ADDENDUM NUMBER 2

**Professional Development Center
and Kitchen**

SAN BERNARDINO CITY UNIFIED SCHOOL DISTRICT
Bid No F16-05

January 5, 2016

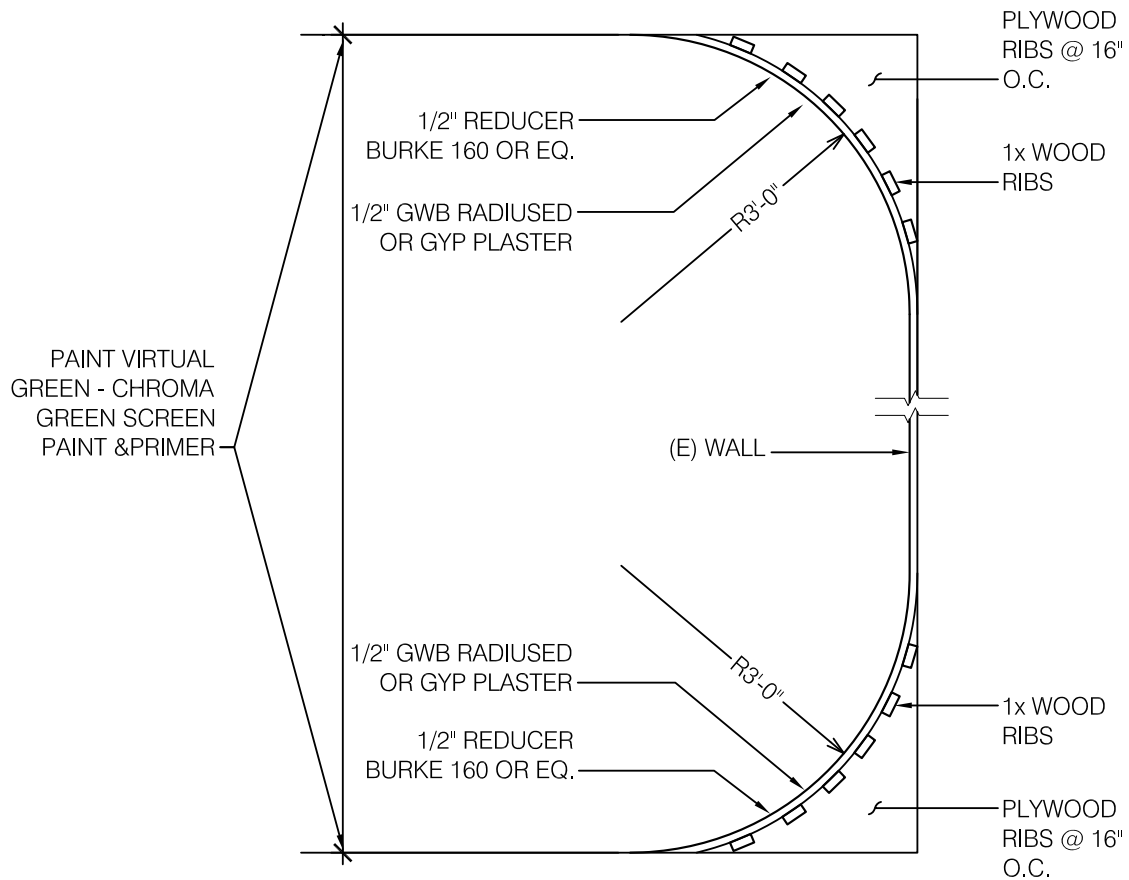
Item Number 14; Reference; Sheet A-6, Second Floor Plan Entire Floor, Detail 28; Replace this detail with attached drawing **AR-01 – Cyclorama Revision.**

Note: The Cyclorama covers the west wall in plan not section as previously shown.

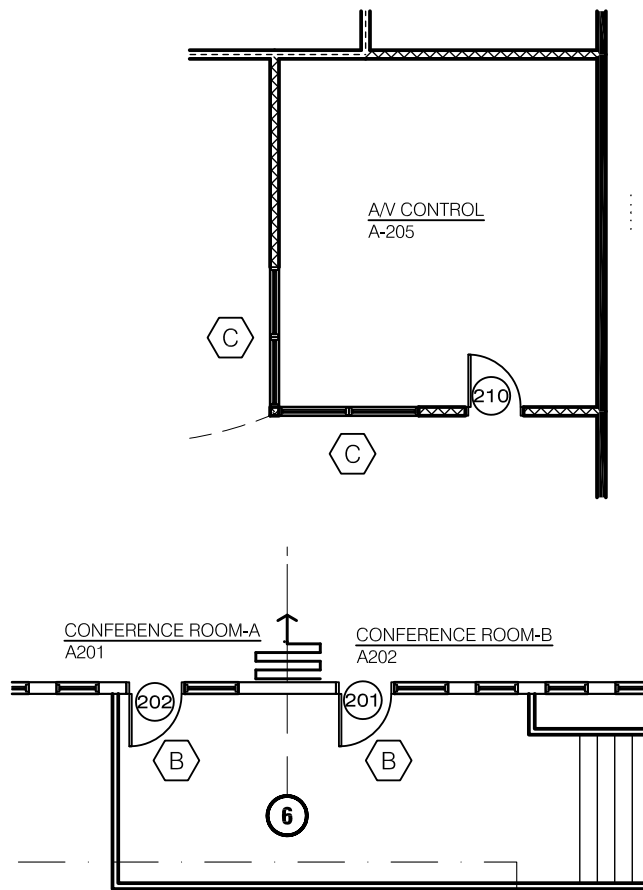
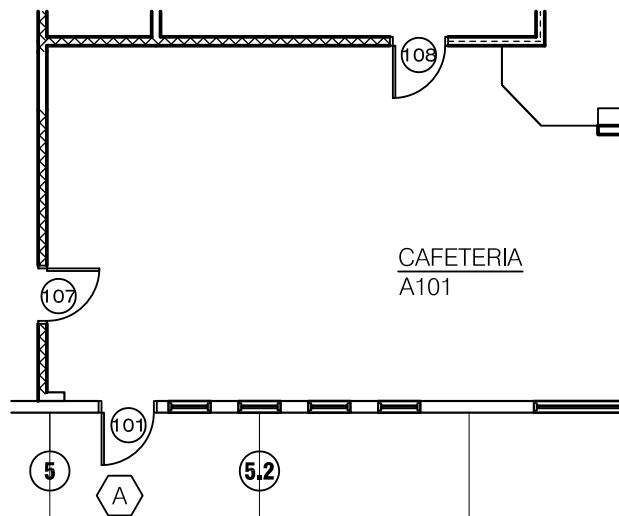
Item Number 13; Reference; Sheets A-3 and A-6; Windows for the Window Schedule are identified on attached drawing AR-02.

FIRST FLOOR LIGHTING PLAN

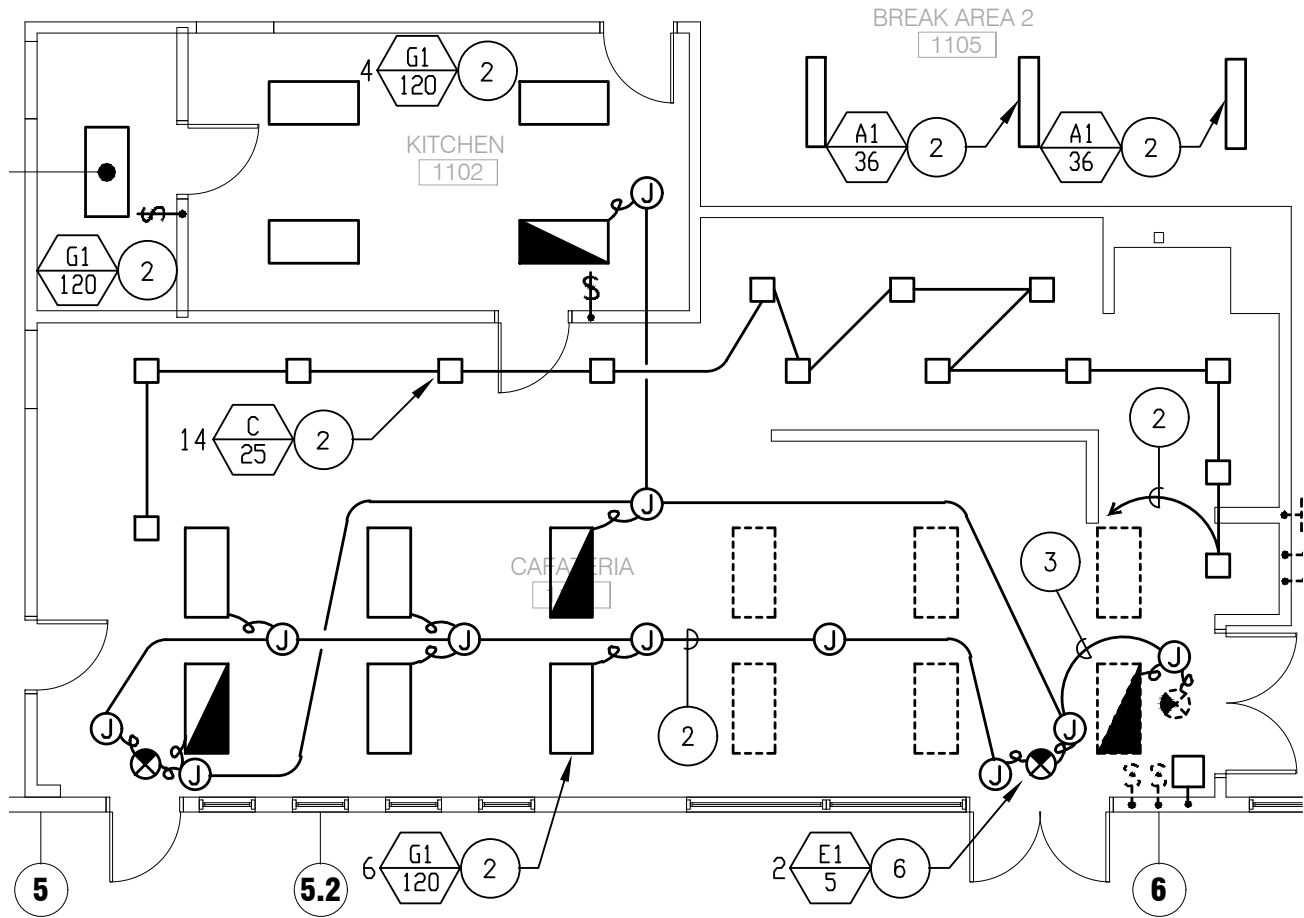
Item Number 29; Reference; Sheet E1.1 First Floor Lighting Plan; Remove existing fluorescent down lights and provide new LED down lights and reconnect to existing lighting controlled circuit as shown on attached drawing **ESK-1**.

FIRST FLOOR PLAN

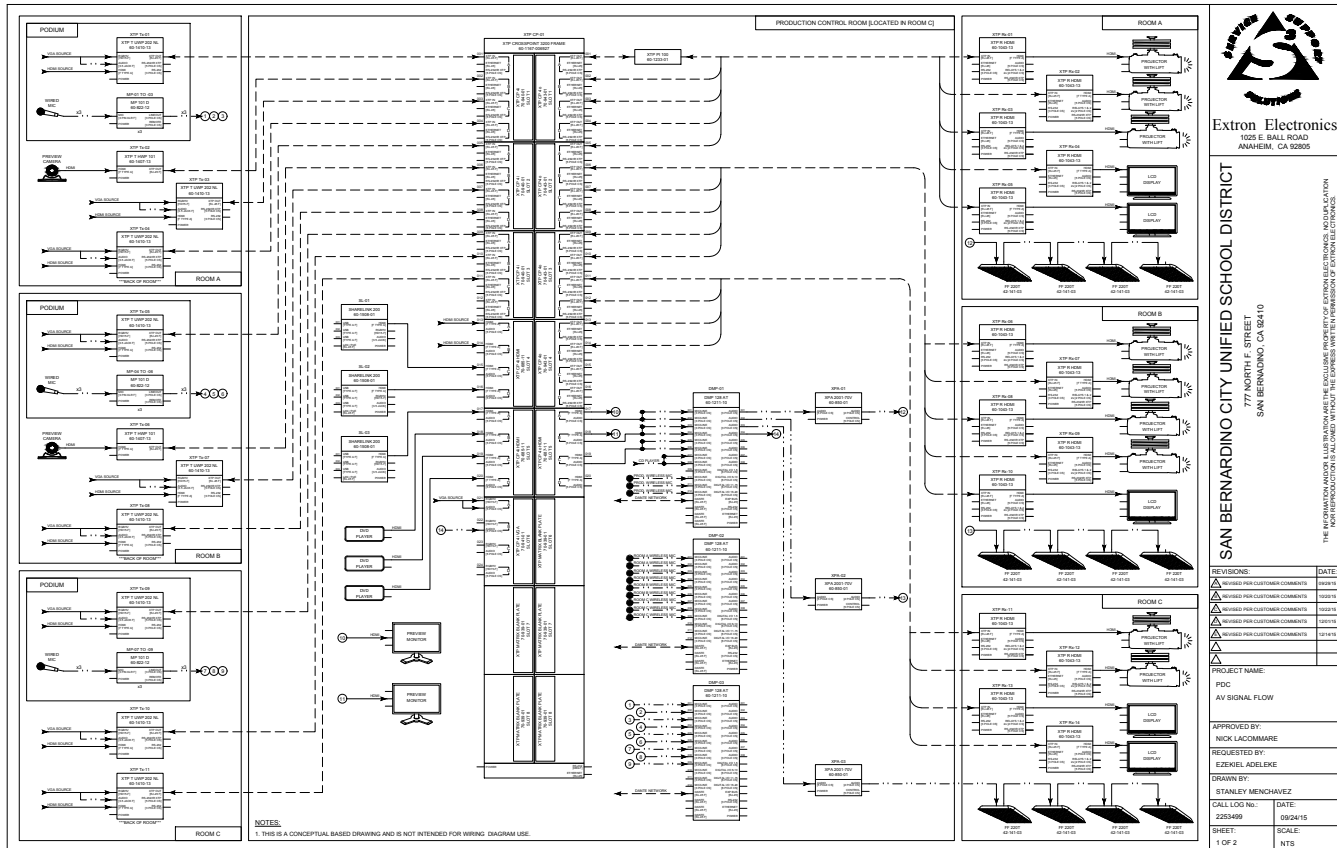
Item Number 28; Reference; Sheet E1.0 First Floor Plan, Detail 2; Replace this detail with attached drawing **ESK-4**, and add Plan Notes 12 – 18 as shown on attached drawing **ESK-5** and add General Notes:

“1. Provide electrical vehicle car charger station with LCD display, weather-proof housing, quick disconnect, 12’ of cord, integrated with Blink Network, charging status, user friendly touch screen, stop timing, wireless IEEE 802.11G and internet capabilities. NEC Article 625 electric vehicle charging system by Blink Network or equal.

a. Provide one (1) Fast Charger Port Station, 480-volt, three-phase input rated at 89 amps, NEMA 3R enclosure. Fast Charger Coupler to be selected by District from types currently available. Provide selection for District review.

b. Provide three (3) Slow Charger Dual Port Station, 240-volt, single-phase input rated at 30 amps, NEMA 3R enclosure. Provide the standard SAE J1772-2009 round coupler and inlet with levels of safety and convenience prevents in advent disconnection, interlock device that prevents vehicle start-up with first in/last out ground.

AV SIGNAL FLOW

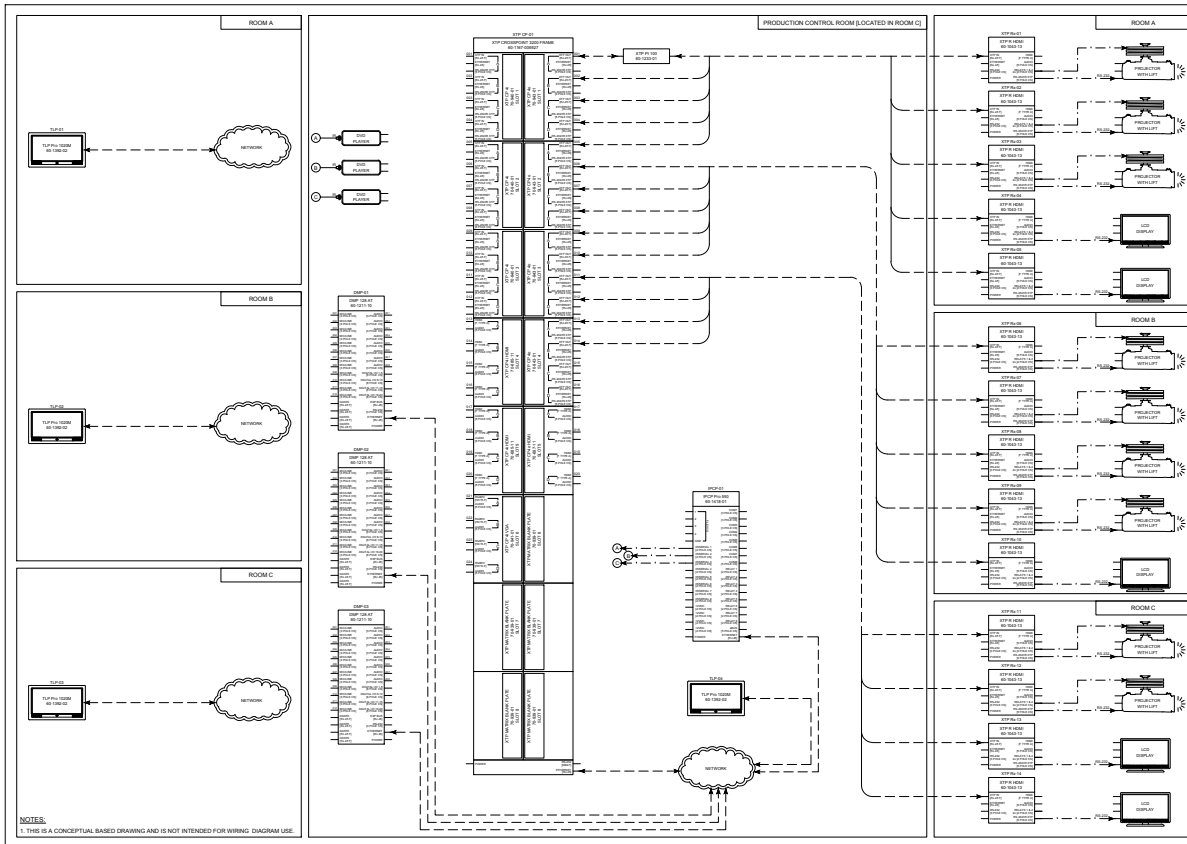
Item Number 25; Reference: Sheet E-6, AV Signal Flow; Replace this sheet with attached sheet **E-6, AV Signal Flow**
